ADDENDUM No. 01

DATE: March 16, 2022

PROJECT: C22-01 SAVANNAH ARTS ACADEMY ADDITION & RENOVATION  
SAVANNAH-CHATHAM COUNTY PUBLIC SCHOOL SYSTEM, SAVANNAH, GA

BY: COGDELL & MENDRALA ARCHITECTS, PC (Architect)  
517 East Congress Street  
Savannah, GA 31401

**PROJECT NO:** 1916  
**DATE:** FEB 2022  
**DRAWN BY:** RML  
**SCALE:** As indicated  
**SHEET:** **A8.01**

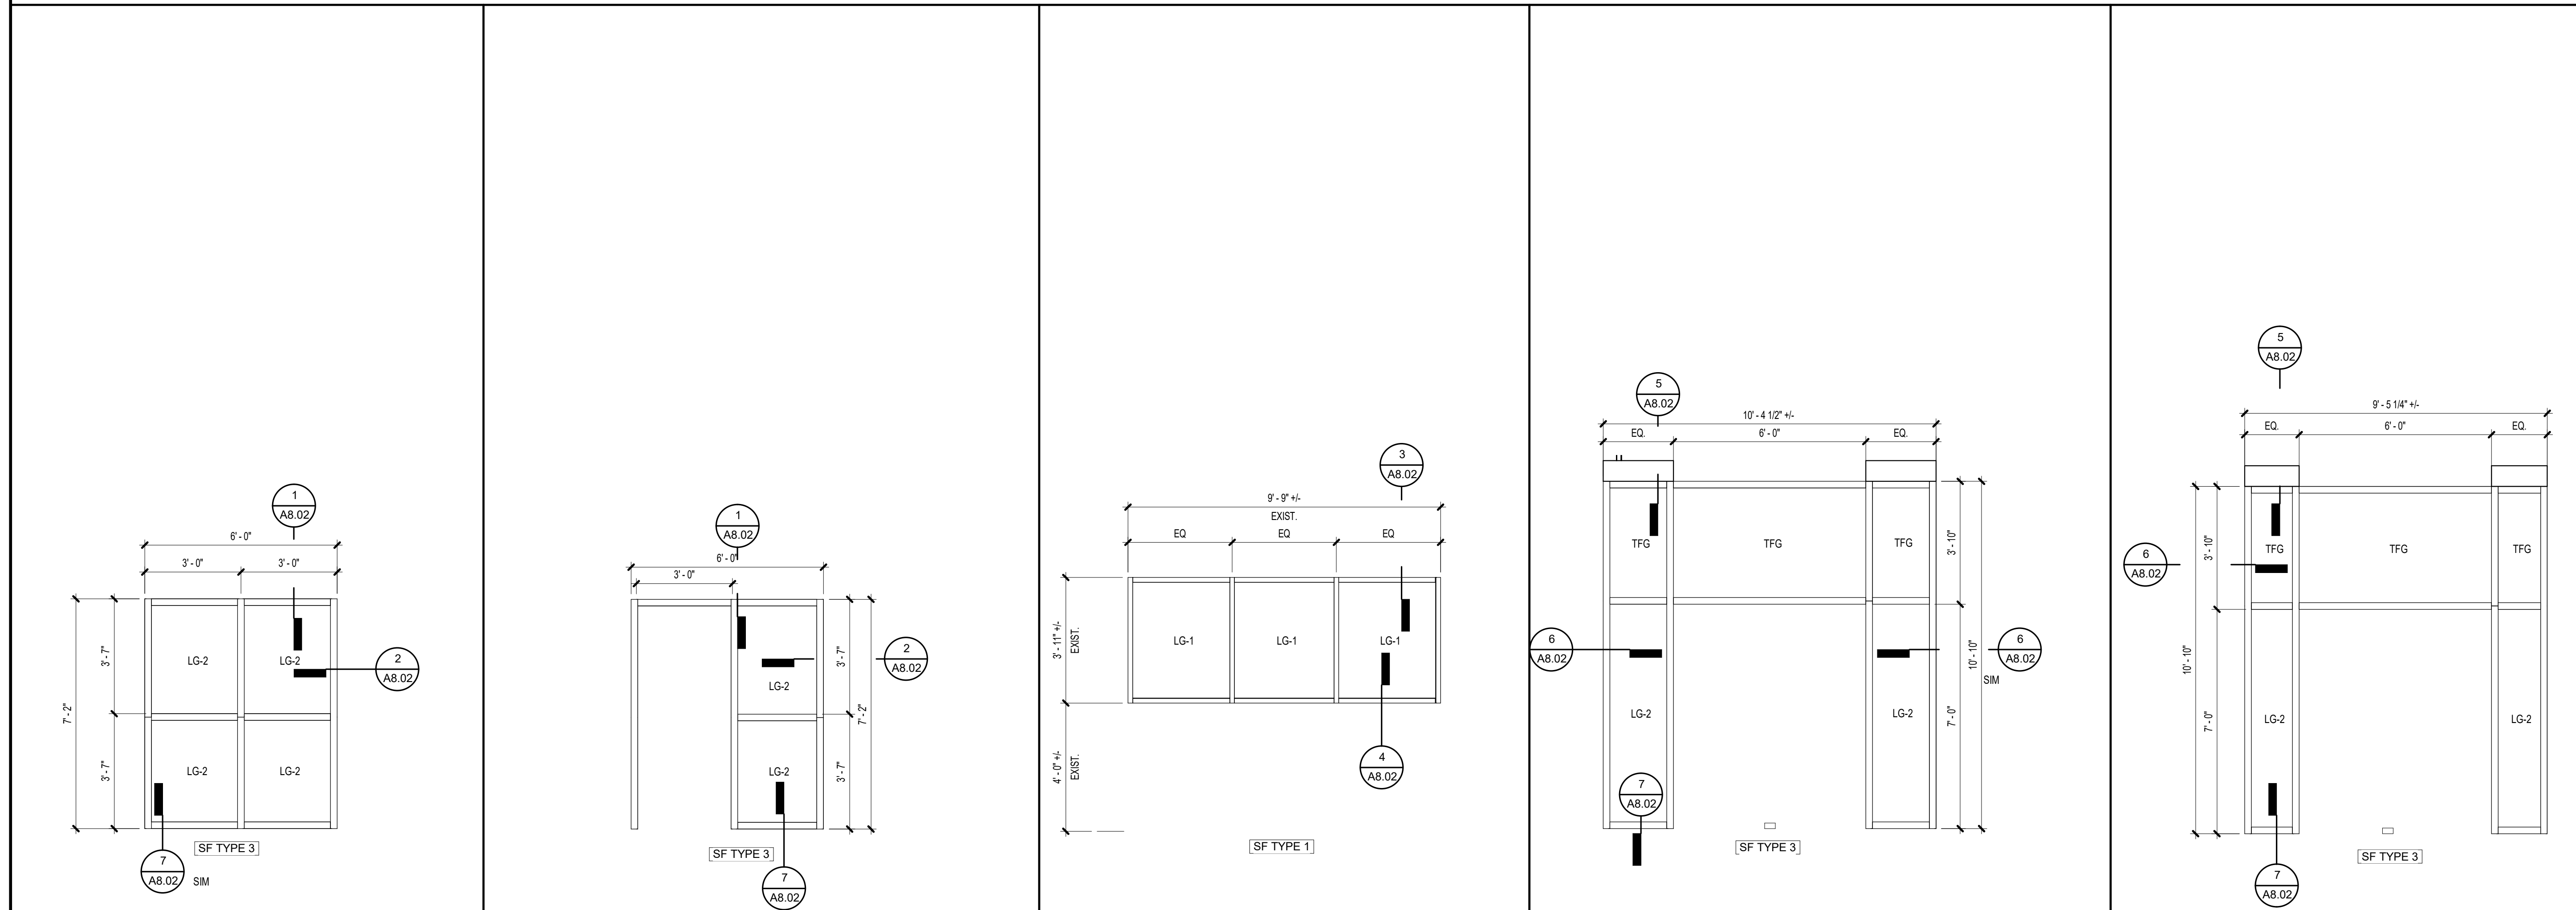
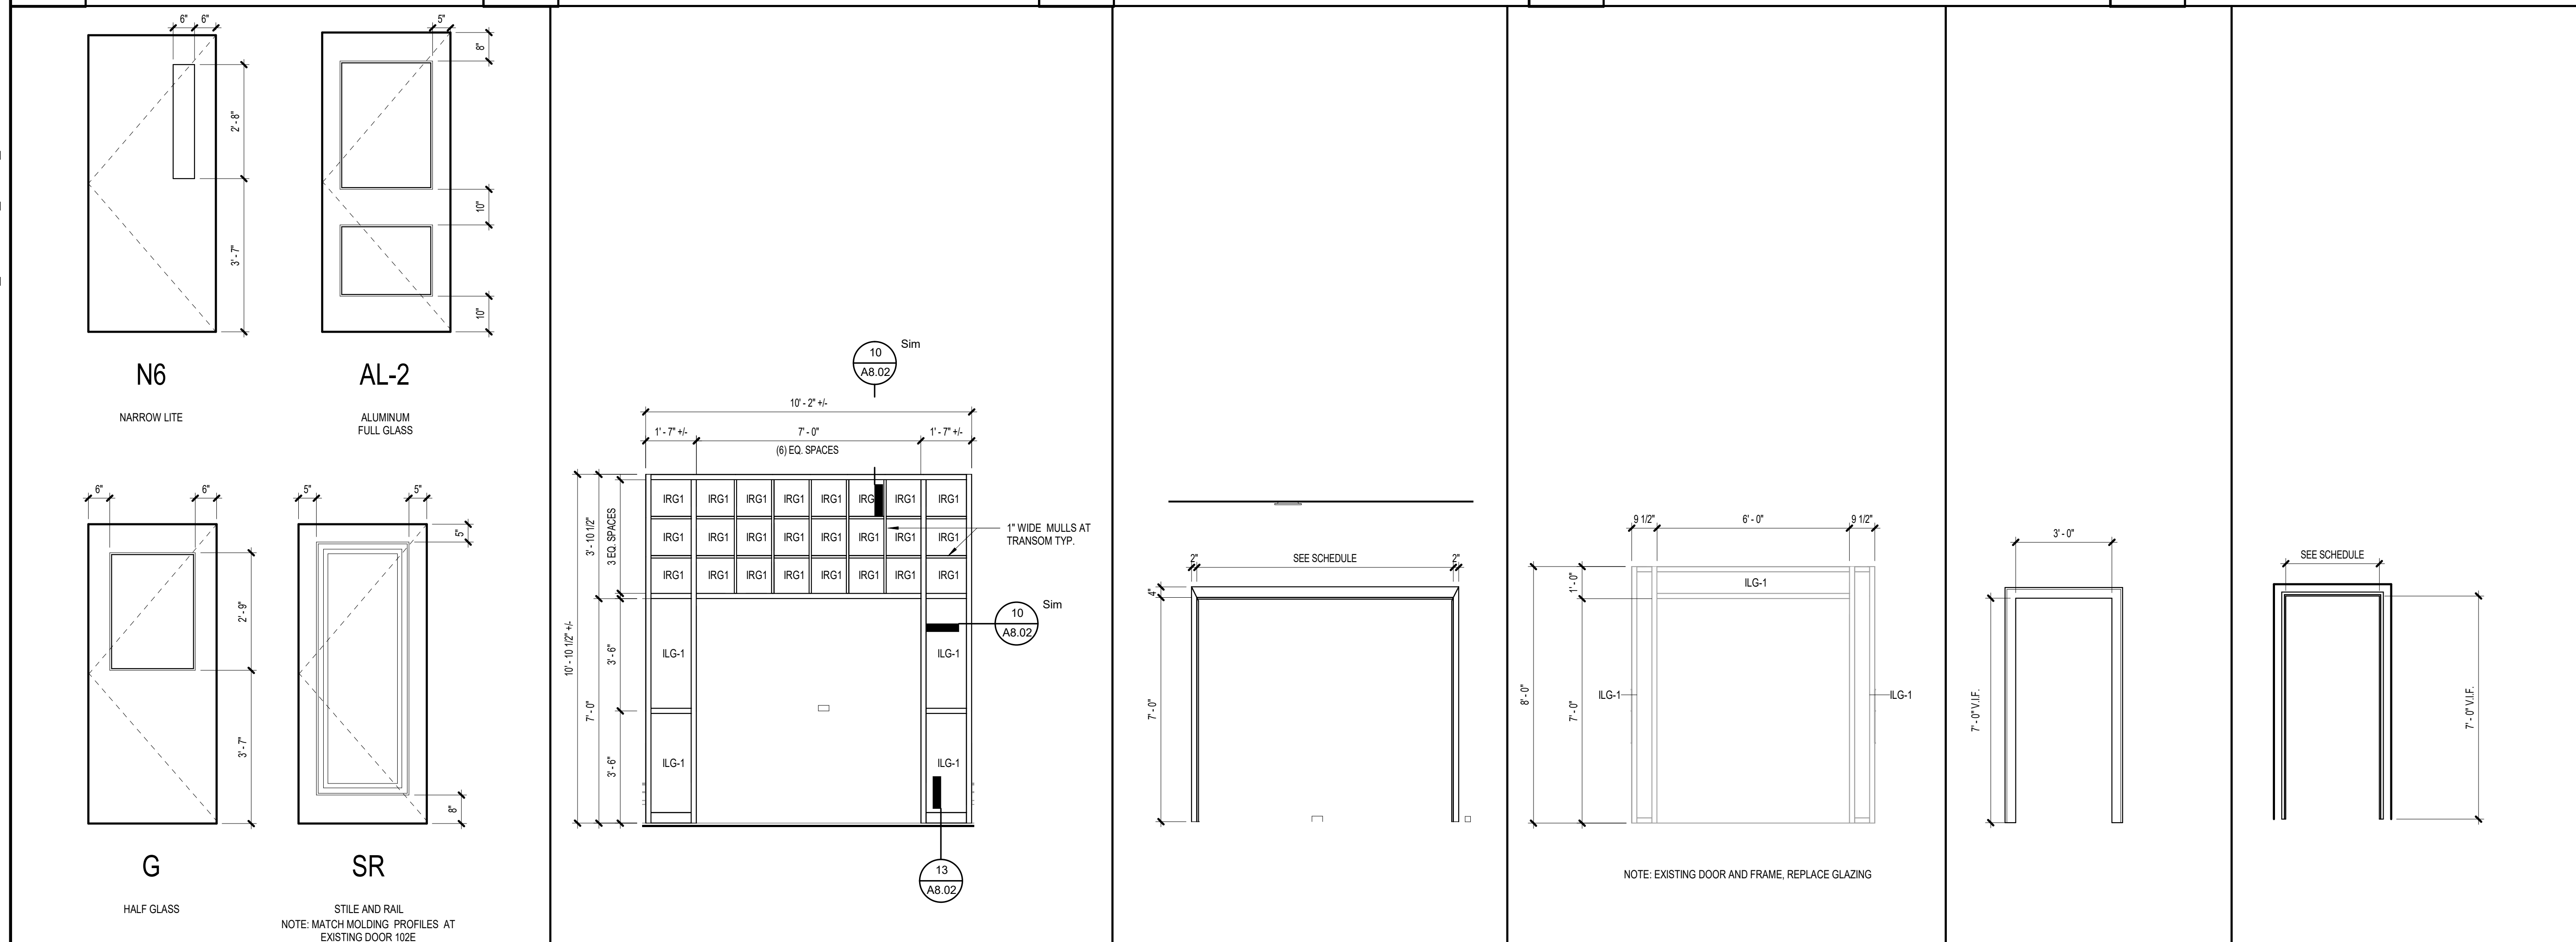
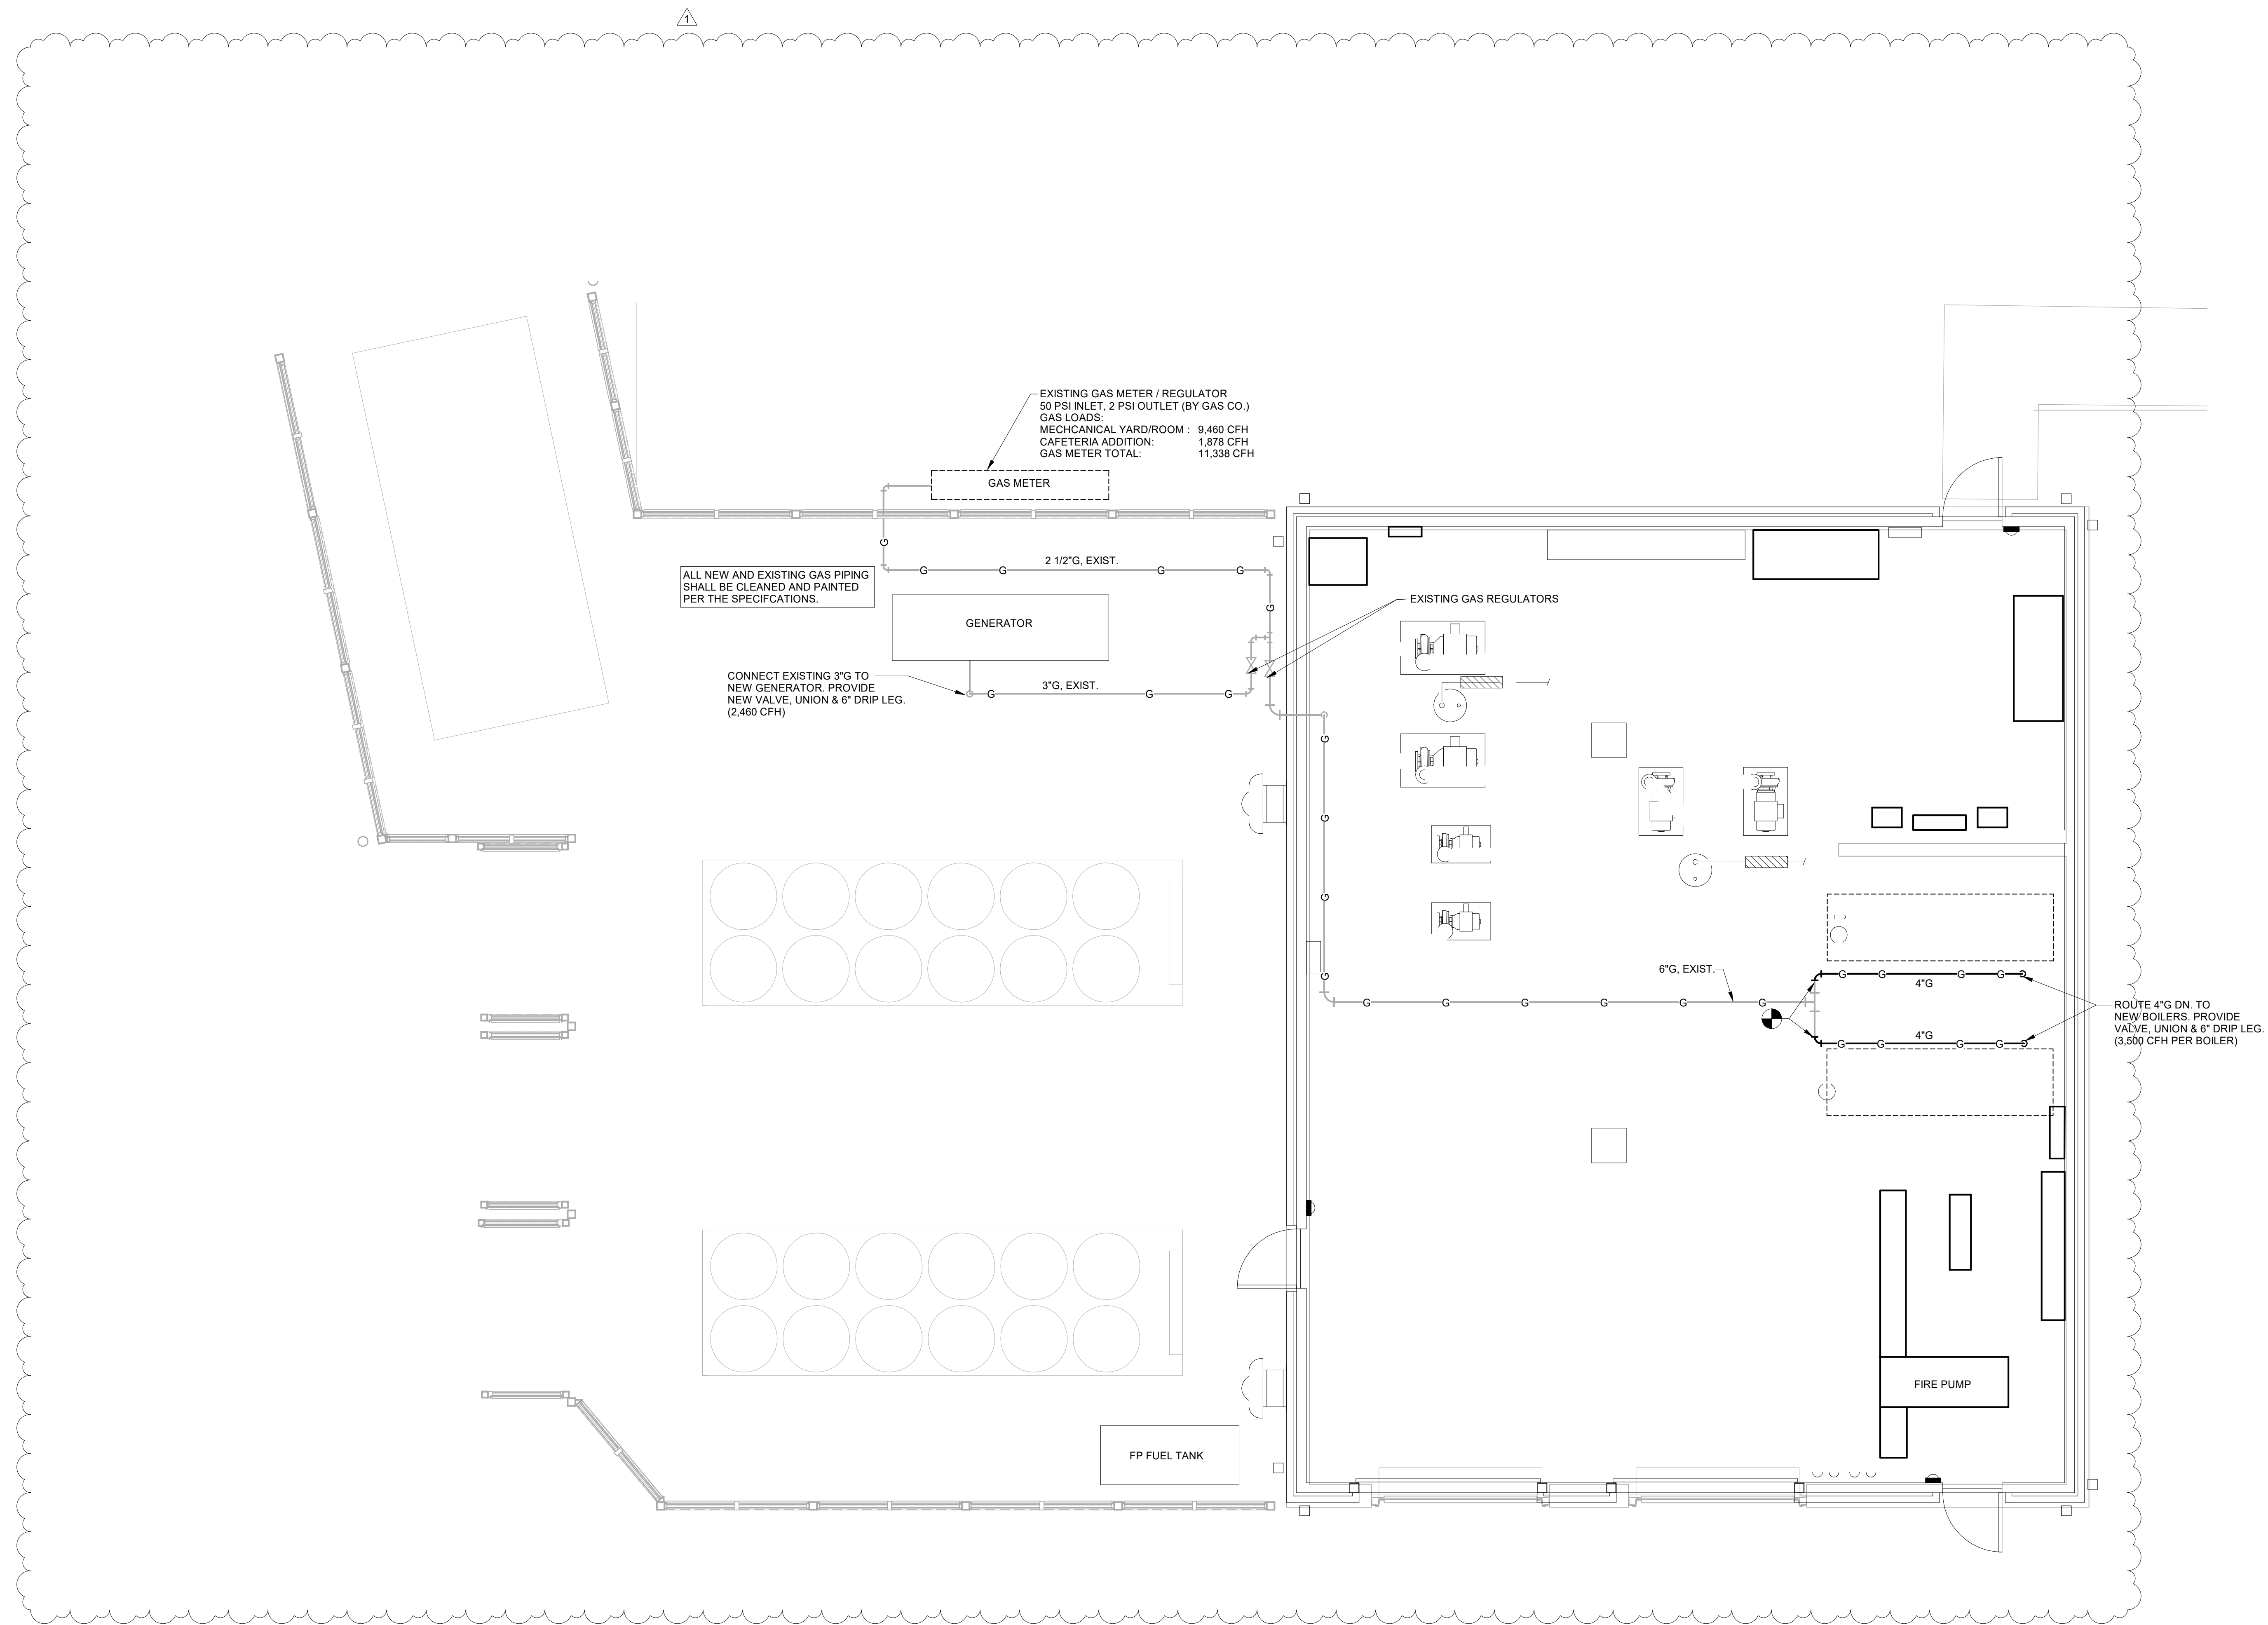
1. Response: Opening is intended to be Wood. Please see revised Vol II – A8.01 for clarification.
- D. Openings 102.E and 127.2 are not scheduled with a Hardware Set and they do not occur in specified hardware sets in Division 087100. Do these openings require new hardware or is all hardware at these two openings existing to be reused?

1. Response: Door 102.E is to have hardware set 12.0. Door 127.2 is noted with remark 5, which is to replace existing glazing. Inclusion in the door schedule is specifying the type of glazing to be replaced. The door and hardware are to remain as existing. Note this glazing is changed as part of this addendum to ILG-2 instead of LG-2. Per Note 1, frame is to be modified as required to receive insulated glass.
